# PROPOSED MODIFICATIONS TO DCAC-370-175-13

13 JANUARY 1989

11. TITLE (Include Security Classification) <b>Proposed Modifications to DCAC 370-175-13 (U)</b>					
12. PERSONAL AUTHOR(S) <b>Roix, Robert; Christensen, John; Namdar, Nina</b>					
13a. TYPE OF REPORT <b>Final Technical</b>		13b. TIME COVERED FROM <b>6/88</b> TO <b>1/89</b>		14. DATE OF REPORT (Year, Month, Day) <b>89, 1, 13</b>

The following are changes to Defense Switched Network (DSN) System Interface Criteria - DCAC 370-175-13, dated April 1988.

FIGURE 9-8 RINGING SIGNAL TELSET (10 IPM)

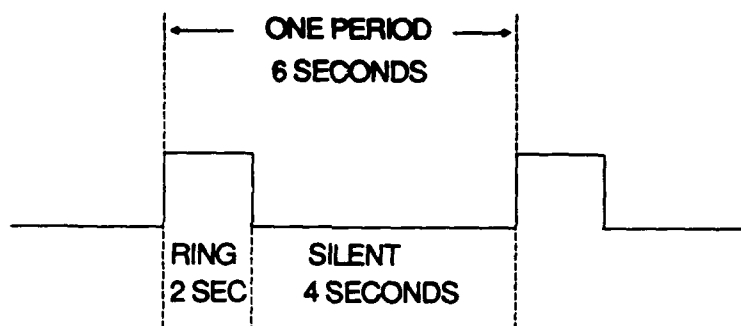
- pg 8-11 Paragraph 4b. Change title to read "End-to-End Bit Count Integrity Consideration."
- pg 8-22 Table 8-9. Delete the word "subject".
- pg 8-27 Table 8-10. Delete the word "subject".
- pg 8-33 Table 8-11. Delete the word "subject".
- pg 8-36 Table 8-12. Delete the word "subject".
- pg 9-1 Paragraph 1a(1)2. Change "Secure-voice" to read Secure voice."
- pg 9-10 Figure 9-7. Change (FCC-99) to read (FCC-98).
- pg 9-14/9-24 Change sentence. "All calls from the DSN toward the PBX are completed by the PBX attendant" to read "All calls from a DSN switch through the PBX are completed by the PBX attendant."
- pg 9-15 Figure 9-8. Change drawing as follows:
